Landscape Review Committee
Hybrid In-Person & ZOOM Online Meeting
Wednesday, February 21, 2024 - 12:00 PM

DATE: February 21, 2024
TO: Landscape Review Committee Members
FROM: Tom Schauer, Senior Planner
SUBJECT: Landscape Plan Review Application (L 55-23)

DATE: February 21, 2024
TO: Landscape Review Committee Members
FROM: Tom Schauer, Senior Planner
SUBJECT: Landscape Plan Review Application (L 1-24)

DECISION, CONDITIONS, FINDINGS OF FACT AND CONCLUSIONARY FINDINGS FOR THE APPROVAL OF A LANDSCAPE PLAN REVIEW FOR PROPERTY AT 645 NW ADAMS STREET

Figure 3b. Landscape Plan

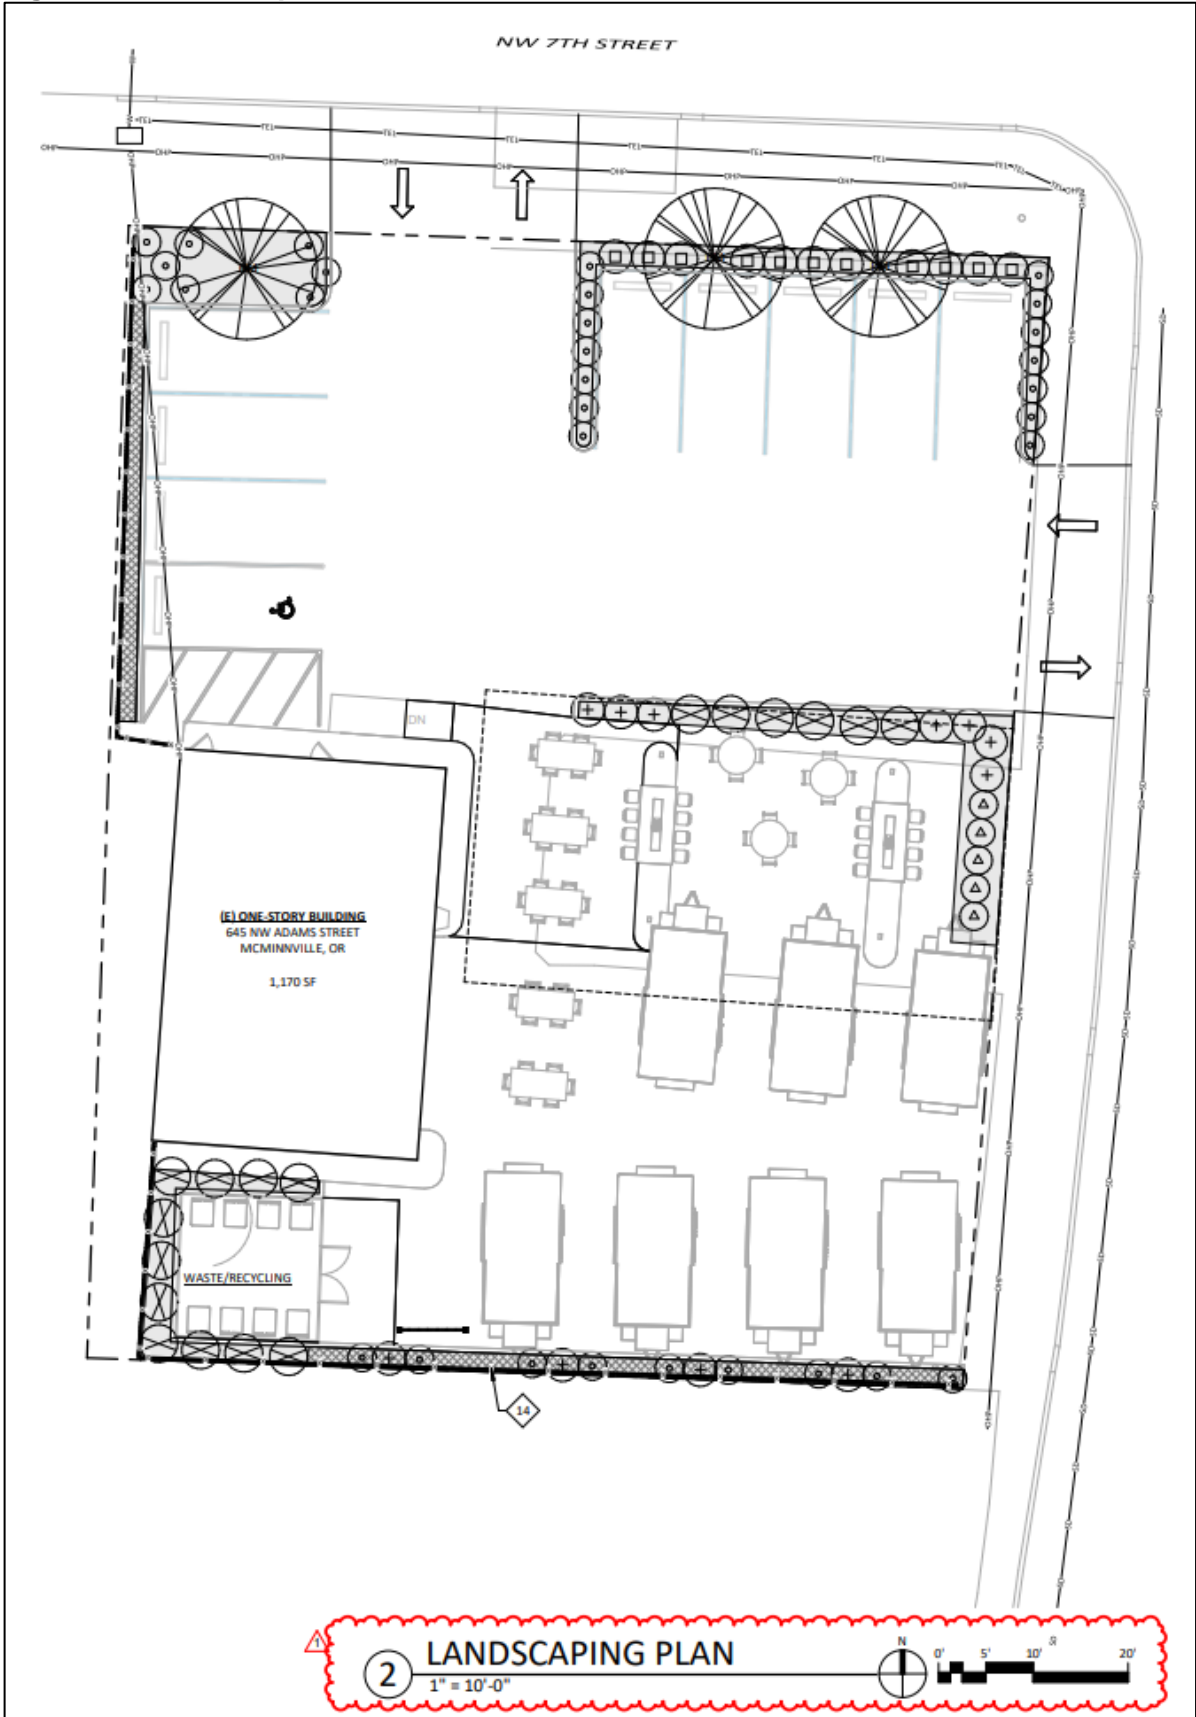
The applicant's proposed site plan and landscape plan are attached and also excerpted below as **Figure 3**. The proposed site plan would establish parking on the northerly side of the property and provide the space for food trucks and seating on the southerly portion of the property. The applicant is proposing fencing and landscaping along the south and west property lines. Landscaping is also proposed behind the sidewalk on both frontages except where there are proposed driveways and along the area east of the food trucks where the trucks would be moved on and off of the property. Landscaping is also proposed between the parking area and the food truck/seating area.

The southwest corner of the site includes a solid waste enclosure for roll-out containers. The landscape plan shows landscape screening on three sides of the enclosure.

Trees are proposed in the planting areas along the north property line, with two crape myrtles east of the driveway and a Bowhall Maple at the northwest corner on the west side of the driveway. Those planting areas and the remaining planting areas are proposed to have shrubs, grasses, and groundcover.

1. Prior to issuance of a building permit, the applicant shall submit a revised landscape plan to the Planning Department for review and approval, incorporating applicable revisions described in conditions below.

2. Ensure provisions of sleeving for irrigation to all irrigated planting areas.
3. Once approved, the applicant shall install landscaping as shown on the final approved landscape plans addressing any required conditions of approval. Landscaping shall be installed prior to final inspection for the building permit, or the applicant shall provide financial surety equal to 120% of the installed landscaping cost as specified in the Zoning Ordinance, and landscaping shall be completed no later than 6 months from final inspection.

Figure 3a. Applicant's Proposed Site Plan

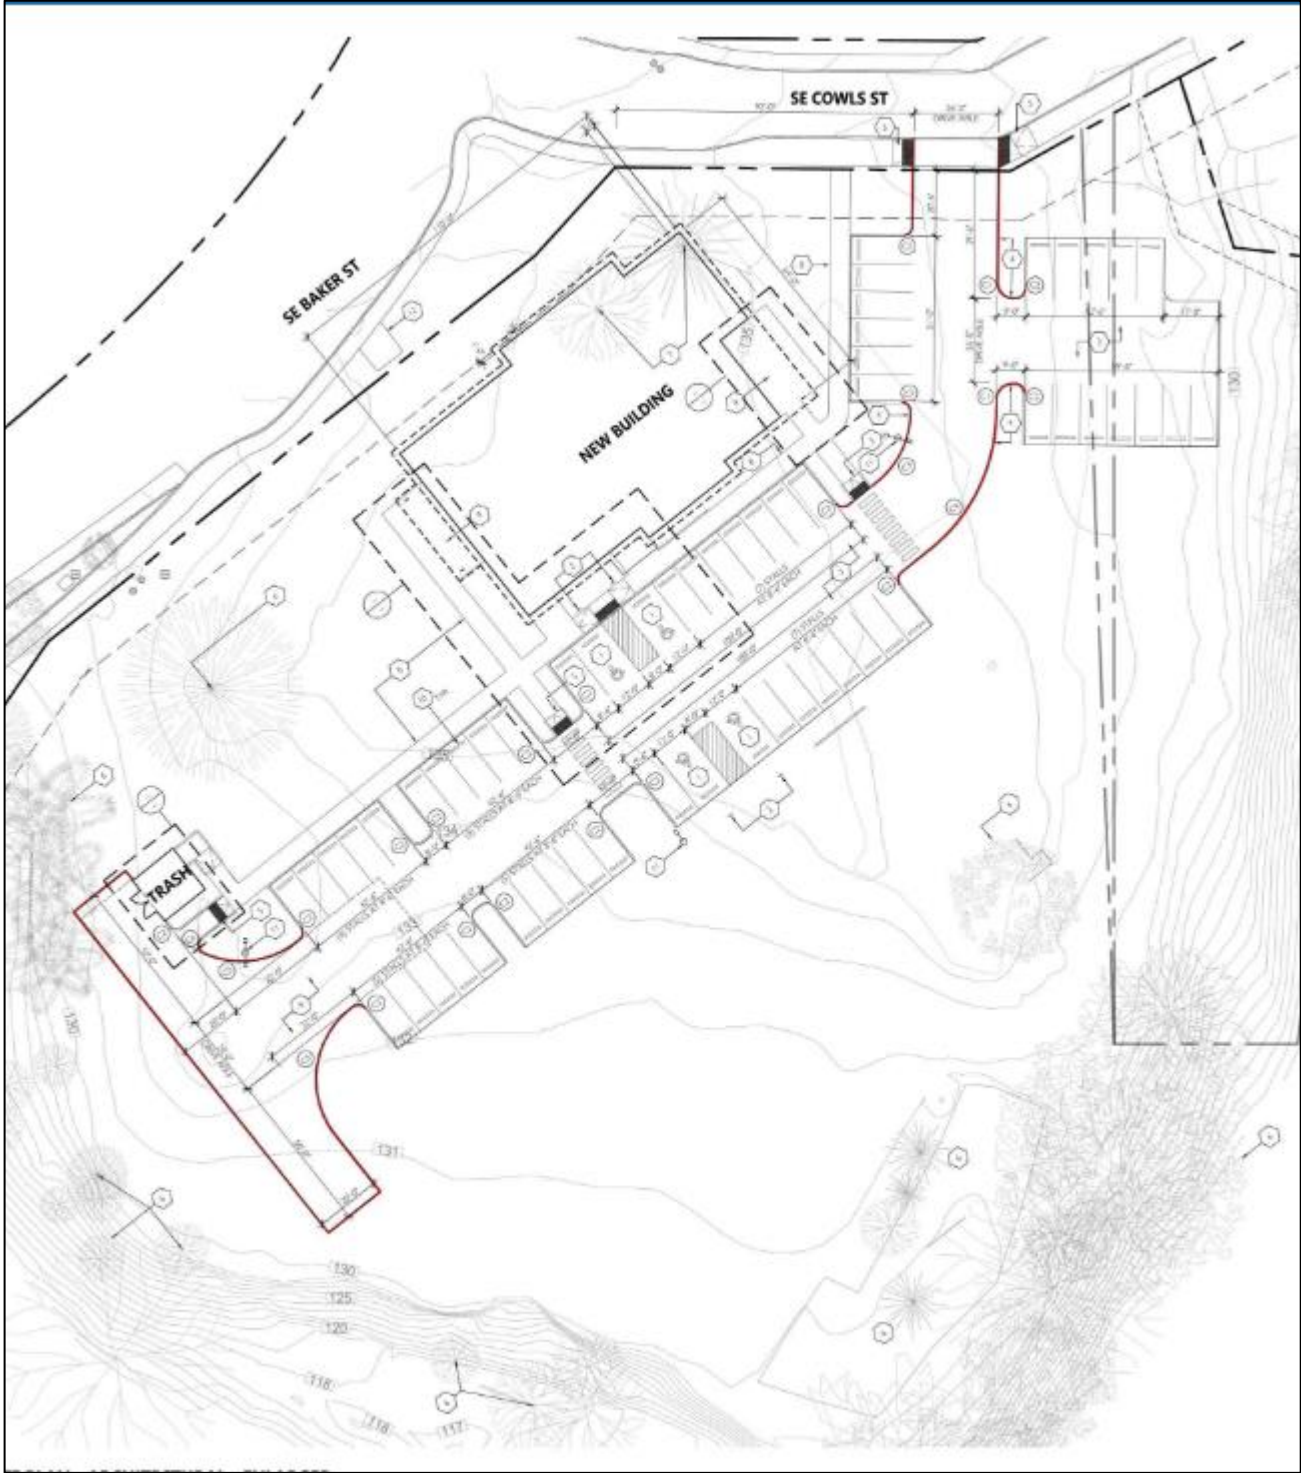
- Additional trees should be added along the Cows street frontage comparable to the standards for size and spacing of street trees as specified in Section 17.58.090(B) of the Zoning Ordinance.

- The property was rezoned in 2018. The ordinance that rezoned the property, Ordinance 5061, includes some specific conditions related to landscaping and trees. One of the conditions requires protection of “existing large cedar tree” and a nearby large oak tree.
- The property to the east is zoned residential, and the subject property is subject to screening requirements between office use and the residentially zoned property and use.
